RFP #2025-07
ADDENDUM #1
Issued 4/7/2025

E501 Electrical Schedules and Details

Your attention is directed to the following interpretations of, changes and additions to the Contract Documents for the project, “Air Cargo Road Overflow Parking Lot & Maintenance Employee Lot” at Syracuse Hancock International Airport.

E501

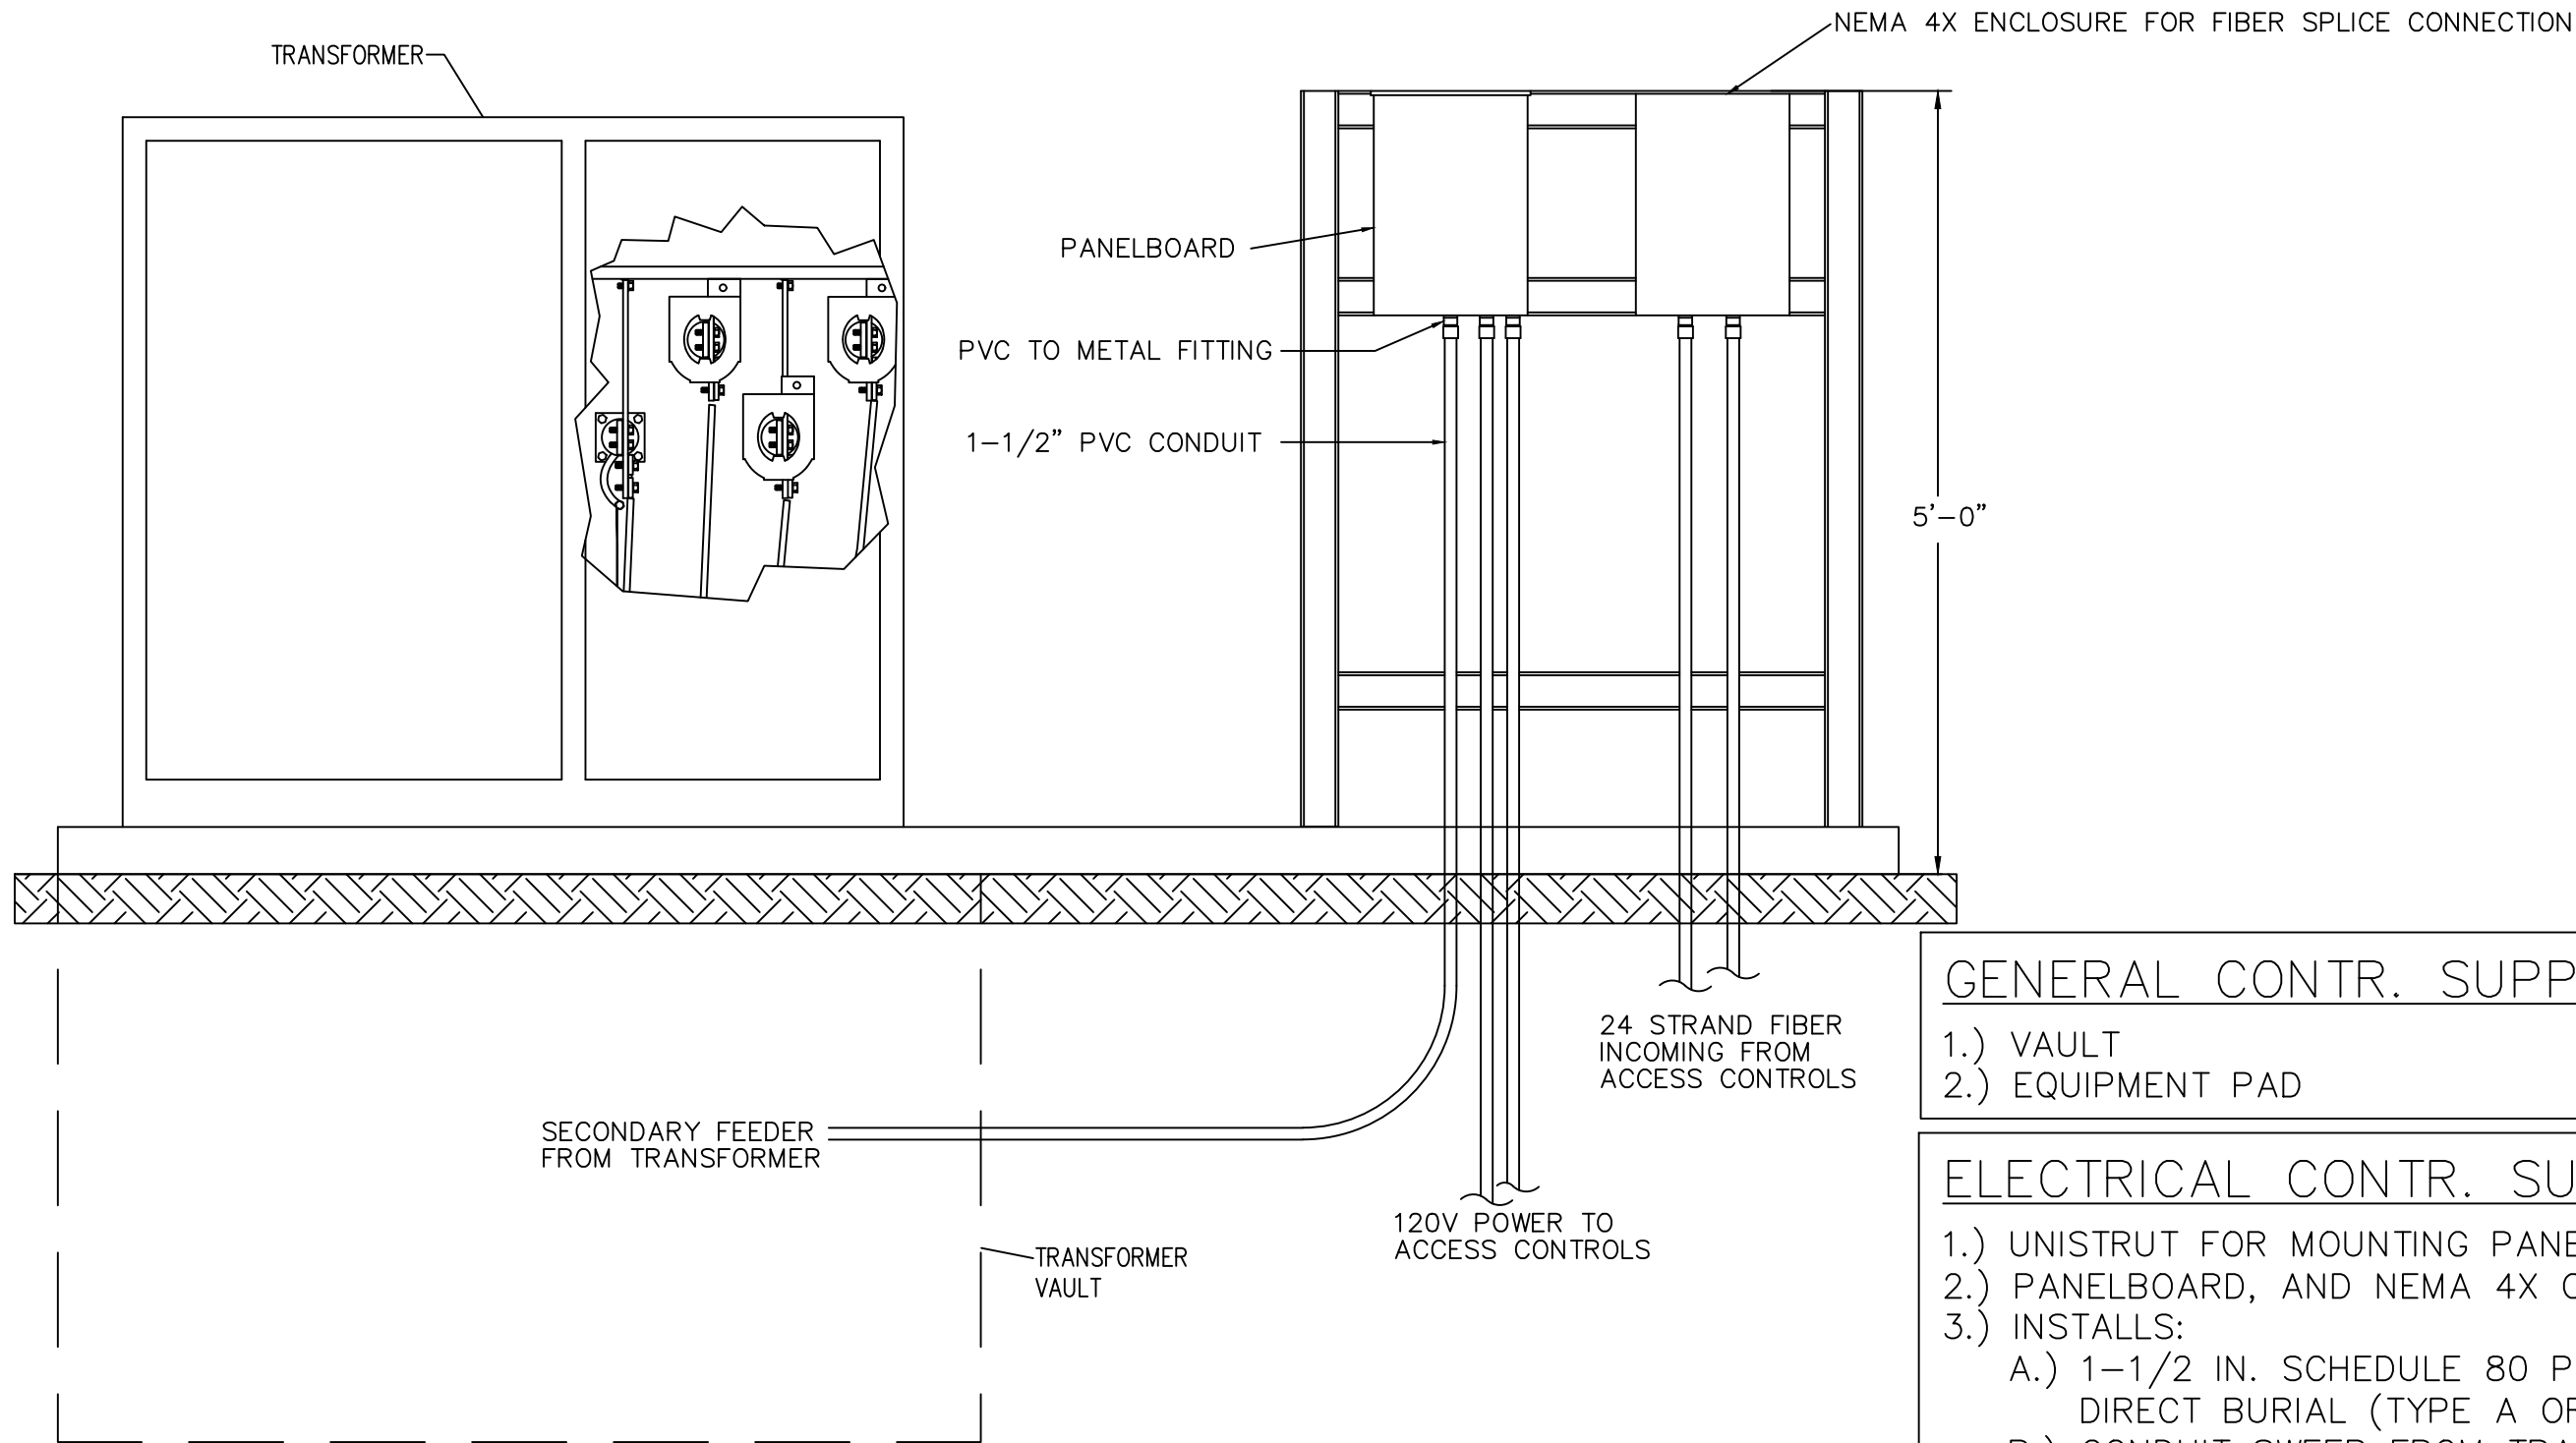
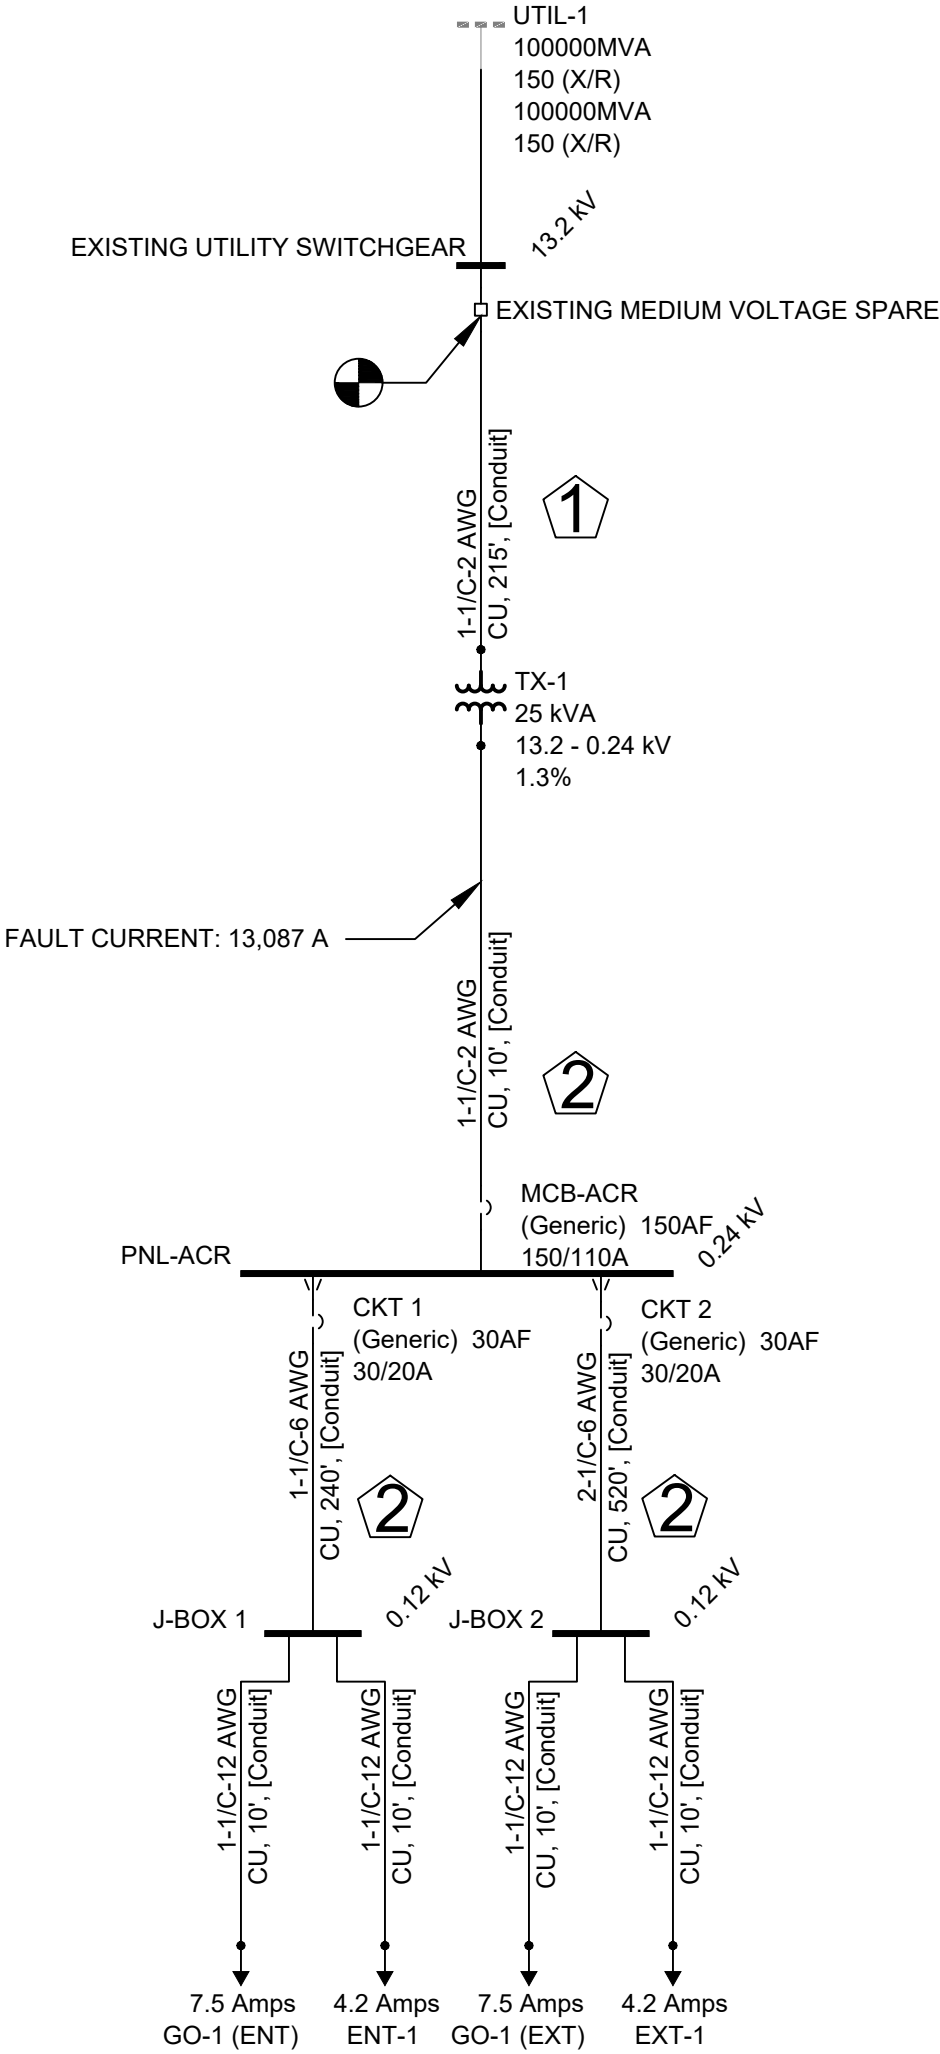
RFI #5: Drawing E501

- a. 13.2 kV feeder from the Existing Utility Switchgear, Spare
 - ii. Detail 2/E501 - Diagram calls for 1-1/C - #2 AWG 13.2 kV feeder from the Existing Utility Switchgear, Spare
Response: Noted
 - iii. Feeder Schedule, feeder 1 calls for 1-1/C - #2 AWG THWN
Response: Revised conductor type to MV-90.
 - iv. Please clarify number of conductors based on the required transformer.

- v. Please clarify Number of sets of conduits and single MV-105, 15 kV, 105 degree C, shielded conductors required.

- i. Detail 2/E501 - Single One-Line Diagram calls for a 25 kV Delta WYE Transformer.

- ii. Transformer Schedule calls for a 15 kV single phase transformer.

- iii. Request: Please Clarify which is desired.

- i. Panelboard Schedule indicates panelboard to be 120/240V, Phase: 1, Wires: 3 when transformer serving it is indicated on the one-line to be a delta/wye.

a. Electrical Branch Circuit Schedule, Pnl-ACR-1, ckt. 1

- i. ckt. 1 - wire size calls for a (1) - 1/C 6AWG.
- ii. Detail 2/E501 - Single One-Line Diagram calls for a (2) - 1/C 6AWG.

b. Electrical Branch Circuit Schedule, Pnl-ACR-1, ckt 2

- i. ckt. 2-wire size calls for a (1) – 1/C 6 AWG
- ii. Detail 2/E501-Single One-Line Diagram calls for a (2)-1/C 6 AWG.

RFI #6: Detail 2/E501 - Single One-Line Diagram

i. Junction Box 1 - wire size calls for a (1) - 1/C 14 AWG.

ii. Conductor size (due to voltage drop)

v. Junction Box 2-Wire size calls for a (1)-1/C 14 AWG

vi. Conductor size (due to voltage drop)

1. Revision: E501

- Revised wire type in Electrical Feeder Schedule
- Revised Transformer Schedule and associated Notes
- Revised Single Line Diagram

**Response: - 1 conductor per phase (or number of parallel sets),
-1/C-One conductor, three separate conductors are used for a circuit, one
for A phase, and one for B phase, 1 for C phase.**

**Response: 1 set of conductors, one conductor per phase. Raceway type
will need to be verified with utility company requirements.**

Response: Install 25 kVA single phase transformer.

Response: Transformer will be single phase transformer-not delta/wye

**Response: This has been revised in the single line diagram. Pnl-ACR-1 CKT 1
requires (1) – 1/C 6 AWG.**

**Response: CKT1 shall consist of one conductor per phase and one full size
neutral (6 AWG) single phase circuit.**

Response: Minimum ground conductor size shall be 12 AWG.

**Response: Pnl-ACR-1 CKT 2 requires (2) -1/C 6 AWG due to the voltage drop
associated with the length of the circuit. Refer to Electrical Branch Circuit
Schedule and Detail 2/E501.**

Response: CKT 2 shall be (2) parallel sets consisting of one conductor per phase, and one full size neutral (6AWG). Single phase circuit.

Response: Minimum ground conductor size shall be 12 AWG.

Response: This has been updated to 12 AWG. Refer to detail 2/E501.

Response: One 6 AWG conductor shall provide for less than 3% voltage drop at 240 ft. circuit length.

Response: The incoming conductor to Junction Box 1 shall be: (1) 6 AWG conductor, (1) full size neutral, and (1) 12 AWG minimum grounding conductor.

Upon making splices with Junction Box 1, the outgoing conductors going to each load shall be: (1) 12 AWG conductor, (1) full size neutral, and (1) 12 AWG minimum grounding conductor.

Final connection to access controls equipment (ENT-1, EXT-1, and GO-1) are limited to a max. wire size of 14 AWG.

Response: 12 AWG minimum grounding conductor.

Response: This has been updated to 12 AWG. Refer to detail 2/E501.

Response: (2) parallel sets of 6 AWG conductors shall provide for less than 3% voltage drop at 520 ft. circuit length.

Response: The incoming conductor to Junction Box 1 shall be: (2) 6 AWG conductor as a parallel set, (1) full size neutral, and (1) 12 AWG minimum grounding conductor.

Upon making splices within Junction Box 1, the outgoing conductor going to each load shall be: (1) 12 AWG conductor, (1) full size neutral, and (1) 12 AWG minimum grounding conductor.

Final connection to access controls equipment (ENT-1, EXT-1, and GO-1) are limited to a max. wire size of 14 AWG.

Response: 12 AWG minimum grounding conductor.
